EXHIBIT B - APPROVED DESIGN

1102 14TH STREET BASALT BOULDER ROCK WALL

City of Oregon City
Public Works Department
APPROVED FOR CONSTRUCTION

☐ Approved as Submitted
☒ Approved as Noted in Red

**CROSS SECTION C
(TYPICAL)**

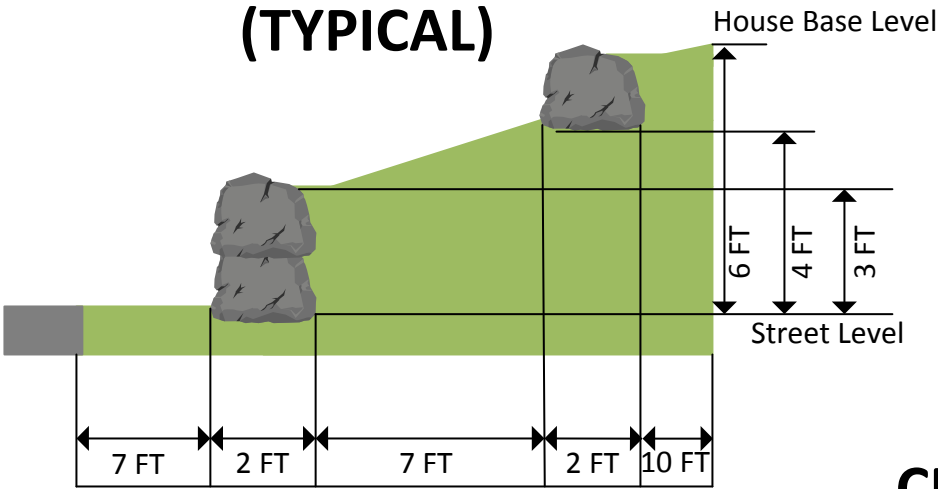
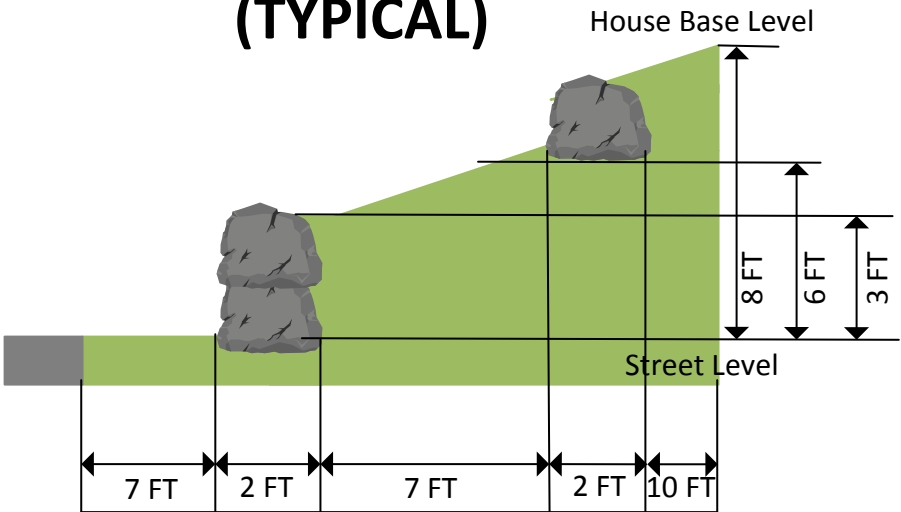
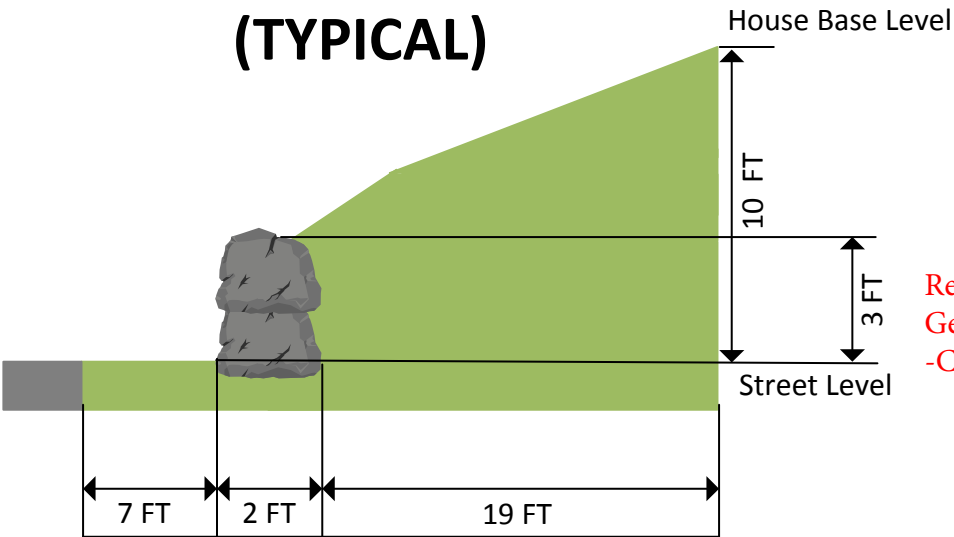
Revised wall height: see included Central Geotechnical Services, Inc. wall revision document.
-City of Oregon City

MAXIMUM ROCKERY HEIGHT (H) = 8 FEET
DRAWING NOT TO SCALE

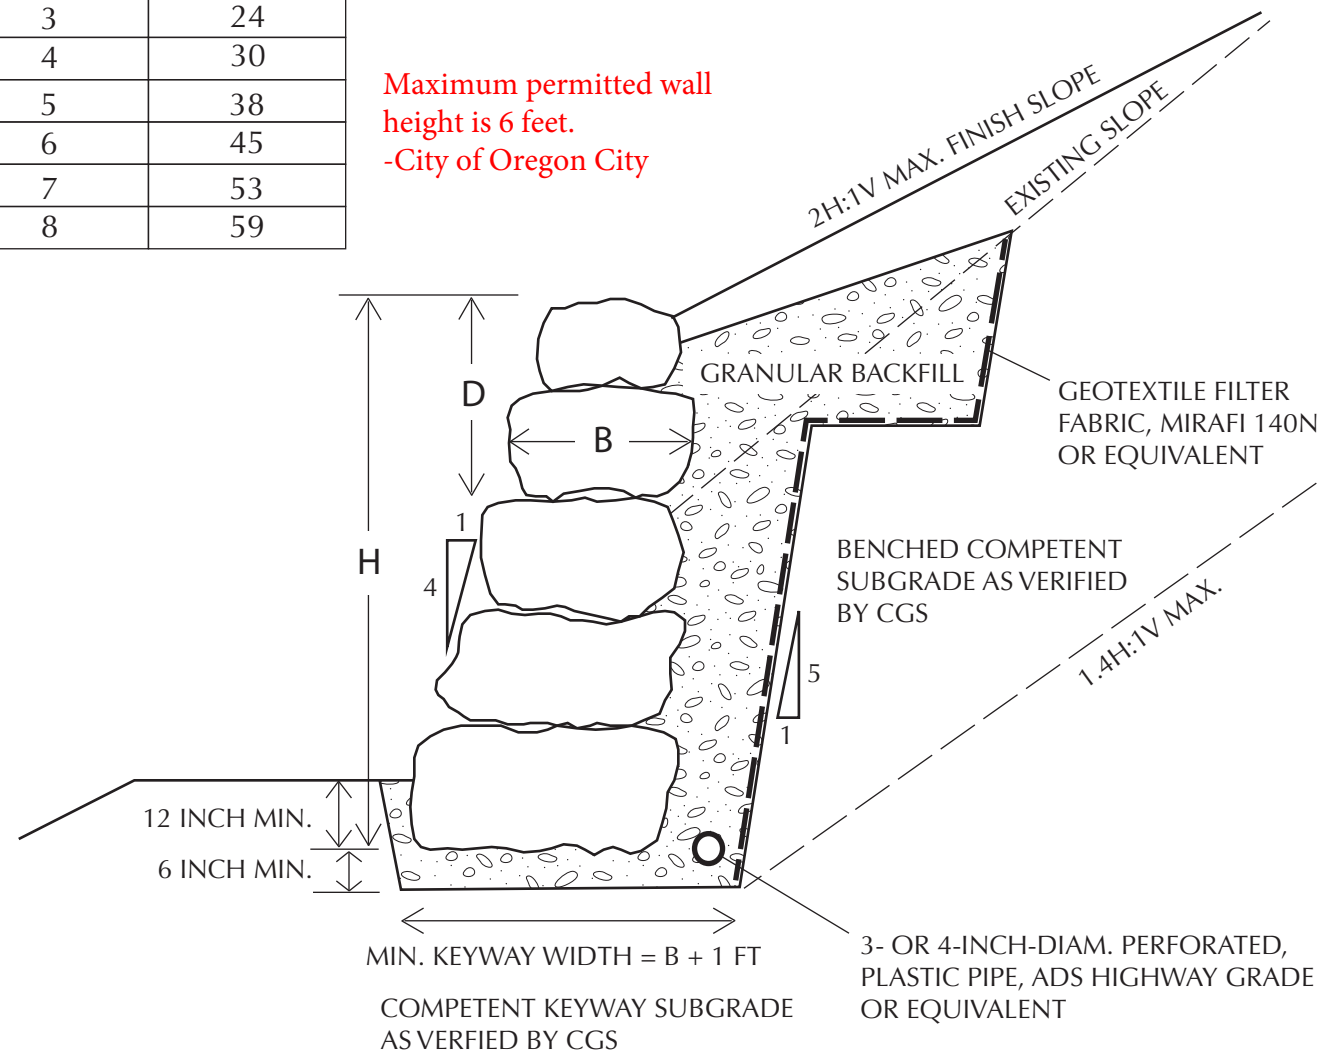
Maximum permitted wall height is 6 feet.
-City of Oregon City
